PRODUCT CHANGE NOTIFICATION

DIN Rail Bracket Replacement

Figure 2: BB-SBD45 DIN Bracket on SmartFlex Router

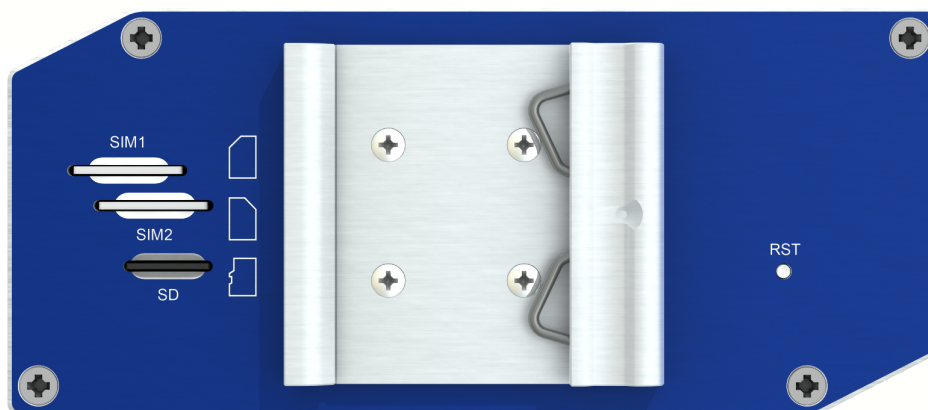
The BB-SBD45 DIN rail mounting bracket, mounted on a v3 router, is displayed on Figure 2.
